SERVICE INSTRUCTION

Introduction of wiring harness options with different lengths for ROTAX® Aircraft Engines Type 912 i (Series), 915 i (Series) and 916 i (Series)

ATA System: 76-50-00 Wiring Harness

Fig. 1

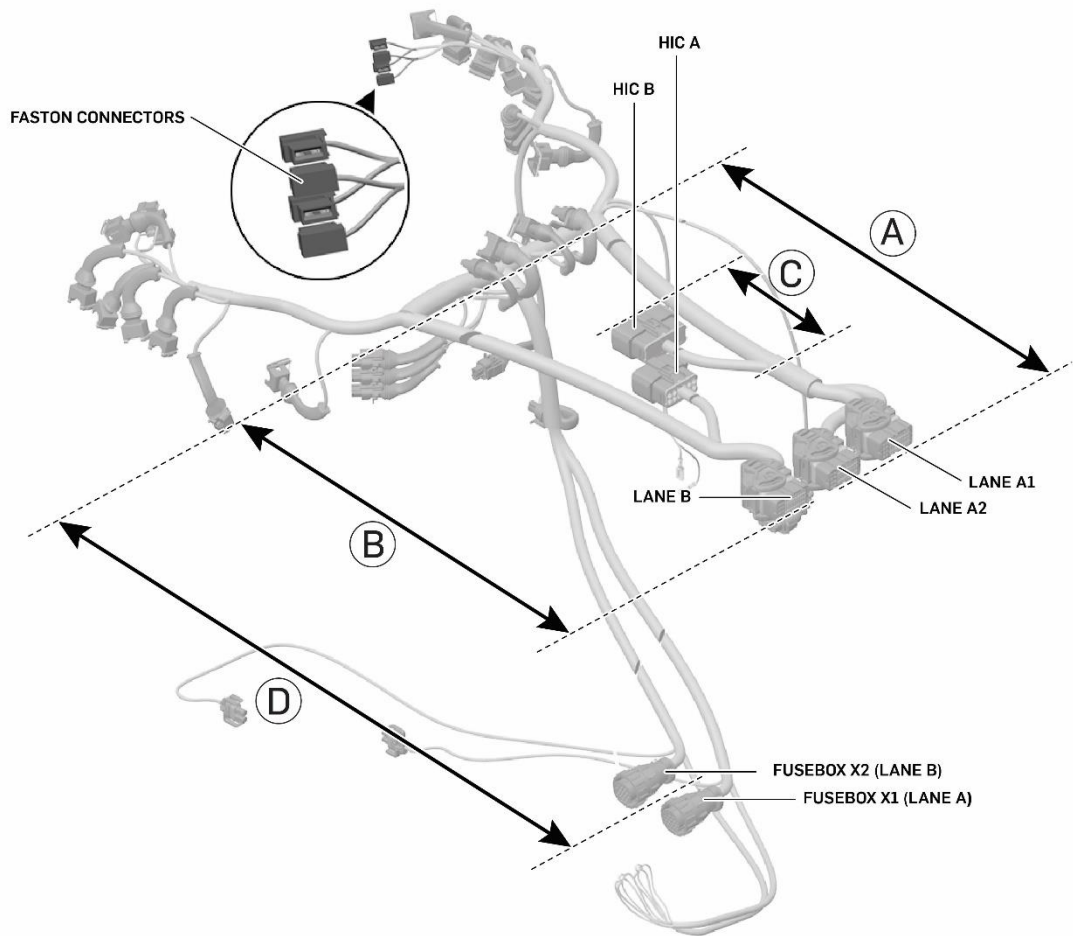
Example wiring harness with FASTON connectors

Engine Series	Harness Type	Part no.	Length "A" ECU Lane A1 & A2	Length "B" ECU Lane B	Length "C" HIC A & B	Length "D" Fusebox X1 & X2
912 i Sport	Standard	665578	1280 mm (50.4 in)	1280 mm (50.4 in)	400 mm (15.7 in)	580 mm (22.8 in)
	(Optional) Short	665573	600 mm (23.6 in)	650 mm (25.6 in)	400 mm (15.7 in)	580 mm (22.8 in)
	(Optional) Special	665574	1150 mm (45.3 in)	1200 mm (47.2 in)	400 mm (15.7 in)	580 mm (22.8 in)
	Standard (New style)*	665621	1280 mm (50.4 in)	1280 mm (50.4 in)	400 mm (15.7 in)	580 mm (22.8 in)
	(Optional) Short (New style)*	665623	730 mm (28.7 in.)	730 mm (28.7 in.)	400 mm (15.7 in)	580 mm (22.8 in)
	(Optional) Special (New style)*	665622	1280 mm (50.4 in)	1280 mm (50.4 in)	400 mm (15.7 in)	885 mm (34.8 in)

Fig. 2
Example wiring harness with TYCO connectors

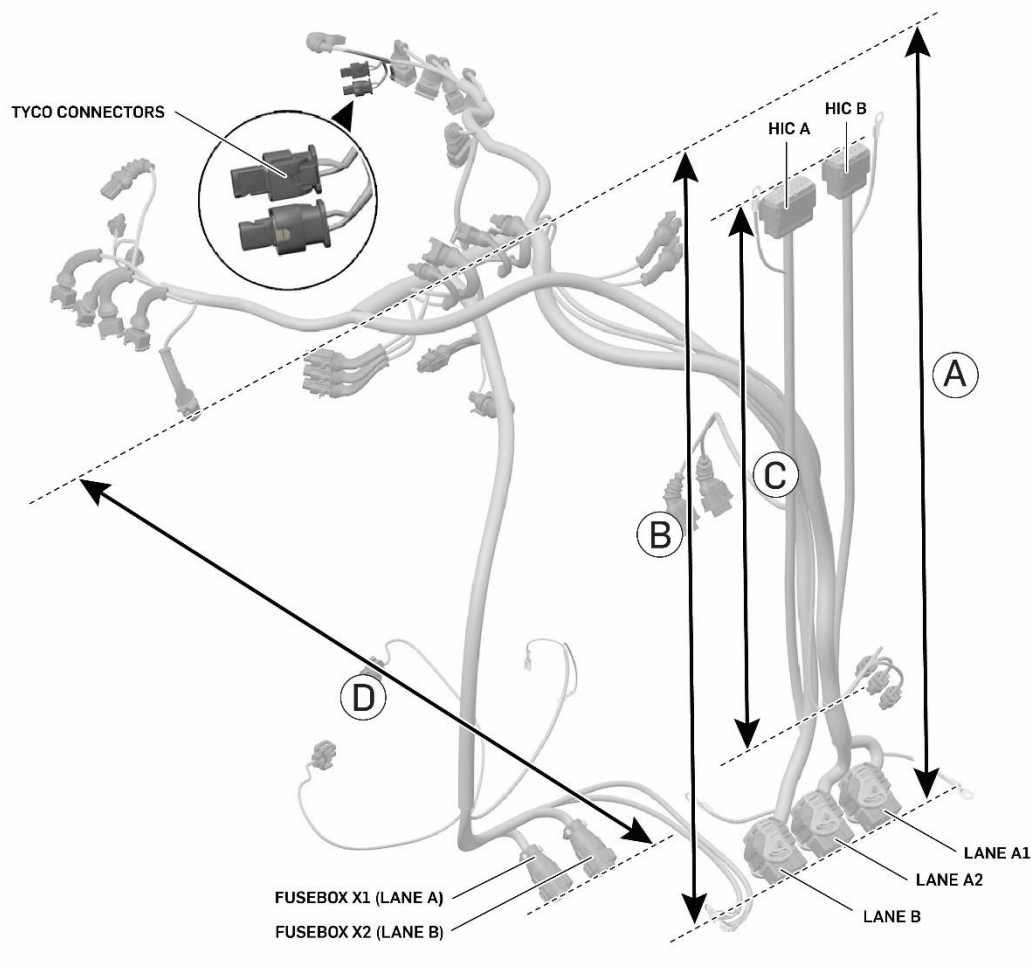
Engine Series	Harness Type	Part no.	Length "A" ECU Lane A1 & A2	Length "B" ECU Lane B	Length "C" HIC A & B	Length "D" Fusebox X1 & X2
915 i A	Standard	665577	810 mm (31.9 in)	960 mm (37.8 in)	500 mm (19.7 in)	810 mm (31.9 in)
	Standard (New style)*	665681	810 mm (31.9 in)	960 mm (37.8 in)	500 mm (19.7 in)	810 mm (31.9 in)
915 i C24	(Optional) Short	665597	241 mm (9.5 in)	402 mm (15.8 in)	A = 34 mm (1.3 in) B = 60 mm (2.3 in)	242 mm (9.5 in)
	(Optional) Short (New style)*	665683	241 mm (9.5 in)	402 mm (15.8 in)	A = 34 mm (1.3 in) B = 60 mm (2.3 in)	242 mm (9.5 in)

Engine Series	Harness Type	Part no.	Length "A" ECU Lane A1 & A2	Length "B" ECU Lane B	Length "C" HIC A & B	Length "D" Fusebox X1 & X2
915 i C24	Standard (New style)*	665688	960 mm (37.8 in)	1000 mm (39.4 in)	450 mm (17.7 in)	740 mm (29.1 in)
916 i A	Standard	665681	810 mm (31.9 in)	960 mm (37.8 in)	500 mm (19.7 in)	810 mm (31.9 in)
916 i C24	(Optional) Short (New style)*	665683	241 mm (9.5 in)	402 mm (15.8 in)	A = 34 mm (1.3 in) B = 60 mm (2.3 in)	242 mm (9.5 in)
	Standard (New style)*	665688	810 mm (31.9 in)	960 mm (37.8 in)	500 mm (19.7 in)	810 mm (31.9 in)
916 iSc B	Standard	665579	960 mm (37.8 in)	1000 mm (39.4 in)	450 mm (17.7 in)	740 mm (29.1 in)
	Standard (New style)*	665686	960 mm (37.8 in)	1000 mm (39.4 in)	450 mm (17.7 in)	740 mm (29.1 in)
